Metropolitan Planning Commission

Staff Reports

June 11, 2015

Proposed Site Plan

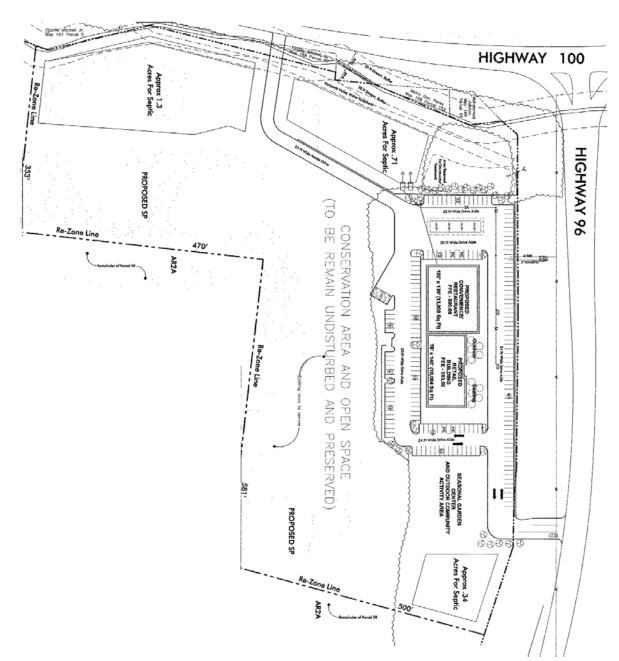
The Rural Neighborhood Maintenance policy is strictly a residential policy that does not include commercial uses. As the SP proposes commercial uses that are not consistent with the Rural Neighborhood Maintenance policy, staff recommends disapproval of the request. In addition, the SP does not have recommendations of approval from Metro Public Works, the Metro Traffic Engineer and the Metro Health Department as the plan does not include the information necessary to address the technical comments of all reviewing agencies.

• There has been no substantive interaction and I do not believe that they have submitted the final copies of the soils map yet. Our office does not issue preliminary approvals. We generally like to have a good idea of estimated water usage and also the soils data so that we can give a more definitive answer which will ultimately lead to approval (or disapproval as the case may be).

- No more than 4' of fill in the HVUD water line easement).
- Install curtain drain around septic area.
- Developer will need to submit Final construction plans to HVUD for approval at the appropriate time.

- The developer's final construction drawings shall comply with the design regulations established by the Department of Public Works. Final design may vary based on field conditions.
- Submit TIS to MPW Traffic Engineer prior to rezoning.
- Indicate sight distance per AASHTO standards.
- If required by Metro Planning, indicate sidewalk construction along property frontage with curb and gutter, grass strip and ADA compliant sidewalks. Coordinate with MPW prior to final design to determine exact specifications of the roadside drainage infrastructure.
- Driveway construction must meet MPW standard drawings.
- TDOT approval will be required prior to building permit sign off.

Proposed Site Plan

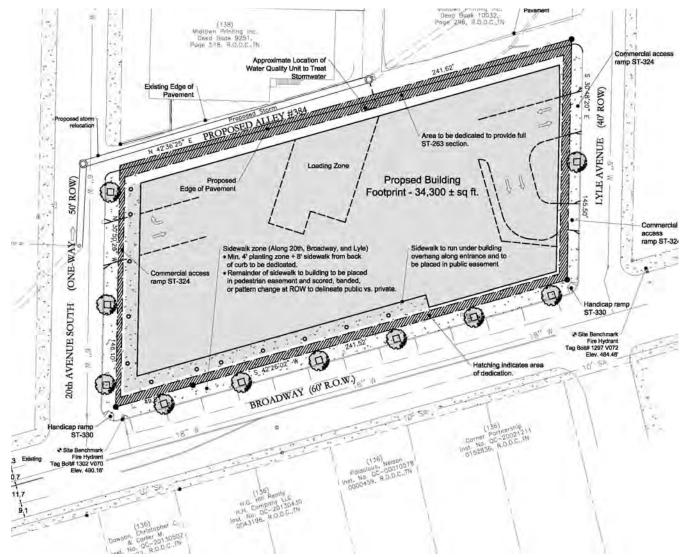
Vehicular access into the site will be from Lyle Avenue and 20th Avenue. There is no vehicular access proposed for Broadway. The plan does call for a valet loading zone along Broadway. Parking is to be provided below grade as well as above the first floor. The plan requires that the upper level parking decks be screened in a manner consistent with the architecture of the building and in a manner that screens cars from view from the street.

The request is consistent with the T5 MU land use policy and meets several critical planning goals. There is an alley located at the rear of the site. While staff would prefer that vehicular access be from the rear alley, the grade difference from the alley to Broadway makes it infeasible. The plan does not permit any vehicular access onto Broadway. There are currently three drives and the removal of these drives and the restriction prohibiting vehicular access onto Broadway will strengthen the pedestrian environment along this stretch of Broadway.

- Building plans shall provide pedestrian access from the site land uses to the valet, taxi zone and parking areas identified on Lyles Ave frontage.
- Developer shall refurbish lane striping on 20th Avenue, S. and Lyle Avenue along the frontage of the project site. Install one way signage per MUTCD standards opposite 20th Ave s access drive. Developer shall sign the Lyle Ave. access points per MUTCD to allow appropriate drive operation. Submit pavement marking and signage plan with construction documents.

- Developer shall install crosswalks and pedestrian hybrid beacons on each approach of the 20th Ave and Broadway intersection. Developer shall submit signal/signage and striping plan to metro traffic engineer and upon approval developer shall install pedestrian infrastructure.

- All valet parking, deliveries, and taxi operations shall occur on-site at the proposed loop access drives on Lyle Avenue. All loading for the residential land uses should occur in the service areas noted on the current site plan. Remove valet area along Broadway frontage identified on SP site plan. Maintain existing curb line to allow a WB travel lane terminating as a right turn lane at 20th Ave. Identify Bus stop and associated bus shelter along Broadway and apply to T&P for restricted parking and loading along Broadway frontage. Developer shall submit striping and signage plan for right turn lane with construction documents. No bulb outs at 20th or Lyle intersection with Broadway will be allowed.

Revised Site Plan Submitted 6/5/2015

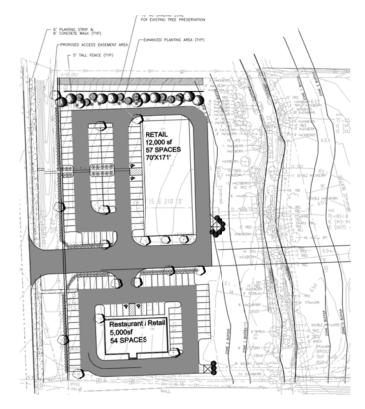
No. The SP is not consistent with the goals of the Suburban Community Center and Suburban Neighborhood Maintenance policies. While the uses may be consistent with the policies, the design of the SP does not meet the policy objective to enhance the pedestrian environment. The plan proposes units that are oriented toward an interior driveway and include front loaded garages. Also, the commercial uses include four rows of parking between the building and Highway 70 South, where the policy calls for no more than one row in order to foster a more pedestrian oriented feel. Given the context along Highway 70 South, planning staff finds up to two rows of parking between the building and the street may be appropriate. Furthermore, the site lacks interior sidewalks that would connect the residents of the multi-family component to the noncommercial uses and to the public sidewalk. This creates an environment that is auto-centric and fails to foster pedestrian connectivity.

In addition, the SP is not consistent with the Conservation policy which encourages preservation of environmentally constrained land. The subject property includes a stream, slopes in excess of 25% and problem soils. While the plan has addressed some of the environmentally sensitive features, the plan includes areas characterized by unstable soils and slopes greater than 20% within the proposed limits of disturbance for the multi-family.

Access to the site is from one driveway onto Highway 70 South. The plan includes sidewalks per the Major and Collector Street Plan but fails to provide interior sidewalk connections from the multifamily to the public sidewalk. The plan does not include elevations or design standards for any of the buildings. If approved, staff recommends that elevations for all buildings be reviewed with the final site plan.

The SP includes several design elements that do not align with the goals of the Suburban Community Center and Suburban Neighborhood Maintenance land use policies. The proposed front loaded garage and lack of an interior sidewalk network fail to provide an environment that enhances pedestrian connectivity. In addition, the four rows of parking proposed in front of the retail building located to the east of the site is not consistent with the Suburban Community Center policy which permits one row of parking between the building and the street in order to create a context that fosters a pedestrian friendly environment.

The SP is inconsistent with the Conservation policy that discourages development in areas with slopes exceeding 20% as well as those characterized by problem soils. The site includes several environmentally sensitive features The proposed limits of disturbance for the multi-family includes areas that exceed 20% slopes as well as soils that may be too unstable for development. At this time, a complete geotechnical study has not been submitted. Metro Stormwater has requested that, if approved, the complete geotechnical study be reviewed with the final site plan.

In addition to the policy concerns, staff finds that the plan lacks the necessary details to determine whether the multi-family development could be sited sensitively. The SP proposes up to 115 multi-family units but shows a plan for 48. Even with the 48 units, it appears that there is difficulty in locating the development outside of areas of steep slopes and problem soils. The SP does not include a complete geotechnical study at this time that would show that the residential units could actually be located in these areas. The flexibility proposed by the SP may not be enough to address the environmental concerns on the site.

The applicant emailed a revised plan on June 5, 2015, that removes the proposed multi-family residential component from the SP and retains the commercial component. The revised plan has not been reviewed by the reviewing agencies. Also, it does not address Planning staff's concerns with the design of the commercial area, as it relates to the Suburban Community Center policy. The Council bill, which includes the plan under review, has already been filed.

- Provide full geotechnical report including information / recommendations for construction prior to final approval.
- Remove impervious surfaces within the zone 2 buffer.
- Add note to plans stating that access to the east shall be constructed to comply with all applicable stormwater requirements.
